Supplemental Responses to Data Request Set 1 (#1–59)

Application for Certification (07-AFC-02)

SAN GABRIEL GENERATING STATION
Rancho Cucamonga, California

DRAWING NO. DESCP-004 REV. 1

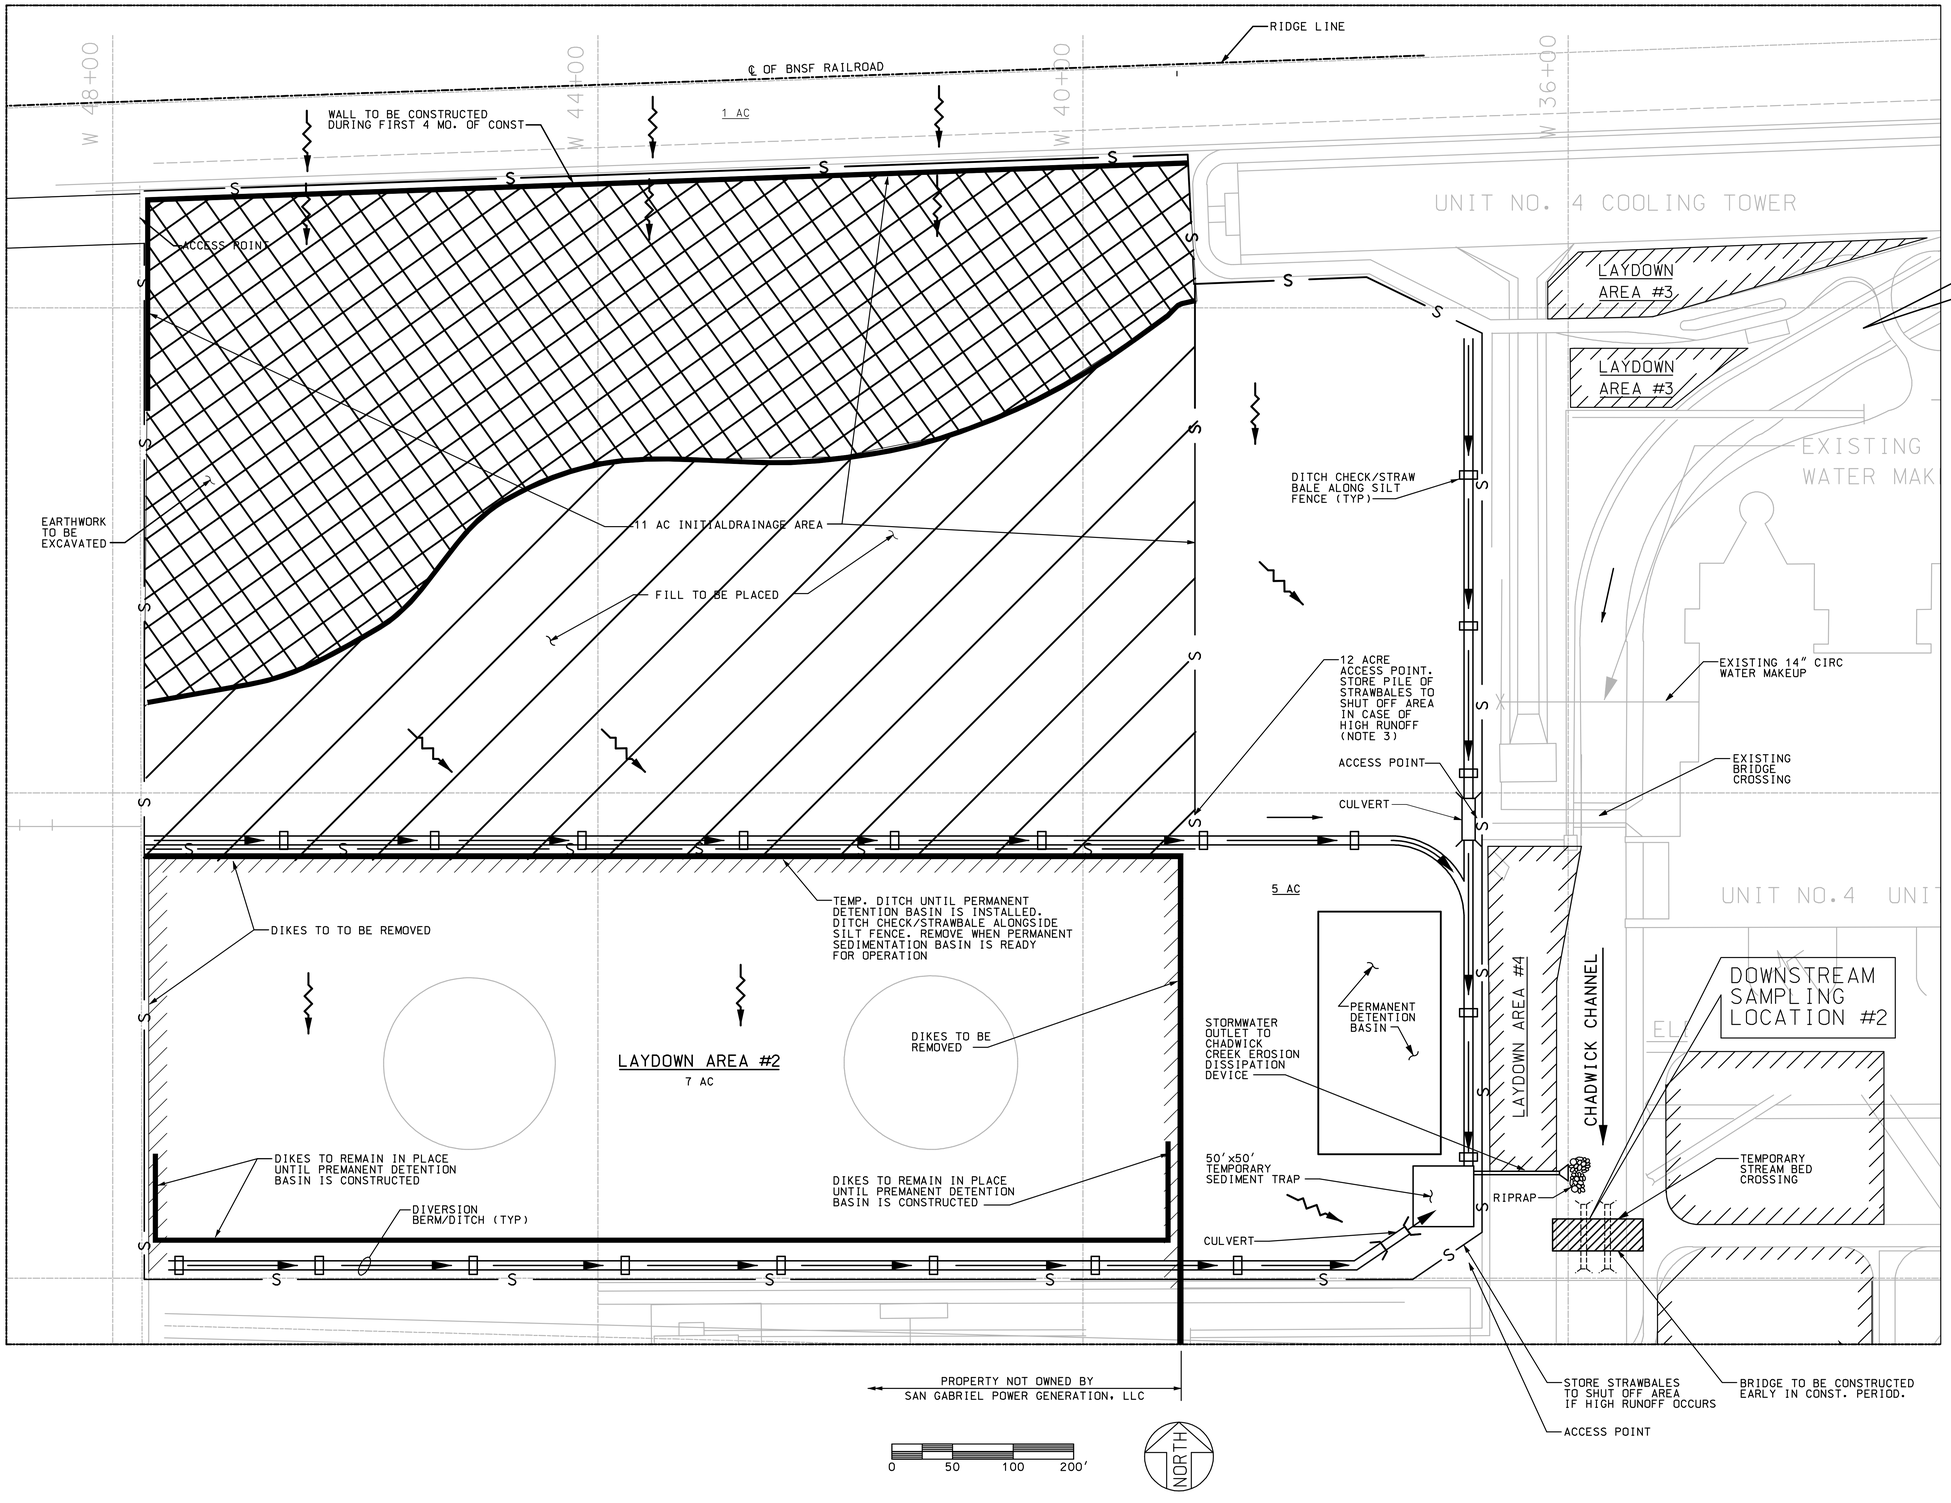
- Staff requested that SGPG revise the DESCP to ensure that mitigation for Wind Erosion (i.e., sweeping) be included in its BMPs for the paved laydown areas within the EGS site.
- Staff questioned whether a temporary sediment trap for drainage until the permanent retention basin would be effective and asked for SGPG to consider a temporary sediment basin rather than a temporary sediment trap.

- The permanent runoff detention basin is scheduled to be constructed in the first 4 months of the project. Until the basin construction is complete, the 24-acre area that will drain into the basin will be separated into three parts using existing dikes, silt fences, and straw bales. The purpose of dividing the construction site into three sections is to mitigate the potential for sediment in runoff during an unusually large rainfall event. The three sections are: (1) the 12-acre plant area north of laydown area #2, which includes 1 acre of railroad track north of the plant area; (2) the 7-acre laydown area #2; and (3) the 5-acre plant area just north and east of the laydown area #2 (see attached Drawing DESCP-004).

A silt fence will be constructed and a ditch with a 4-foot-wide bottom with straw bales on 100-foot centers will be constructed where the northern dike of the tank farm currently exists. The ditch will tie into the ditch along the eastern side of the property that drains into the sediment basin. A pile of straw bales will be provided near the access point of the 12-acre area. The straw bales will be used to close off the area if runoff is high. A pile of straw bales will also be stored near the southeastern corner of the temporary sediment basin to closeoff that area in case of high runoff. See Drawing DESCP-004 for details.

The 2-year, 24-hour runoff from the plant area was calculated using data from NOAA Atlas 14. The ditches with straw bales will drain into the sediment basin, which will have 3H:1V side slopes and be 6 feet deep, with one foot of freeboard. The top elevation will be approximately 1,112.5 feet and the bottom elevation 1106.5 feet. The sediment basin will have a perforated stand pipe and a 12-inch-diameter outlet pipe. The basin, plus the east west drainage ditch, will have the capacity to store a volume greater than the 2-year, 24-hour runoff for the 17 acres.

After the permanent detention basin has been constructed, the two temporary ditch systems will be tied to the basin, and the east-west ditch (i.e., former location of the north tank dike) will be removed. Also, the silt fence and ditch
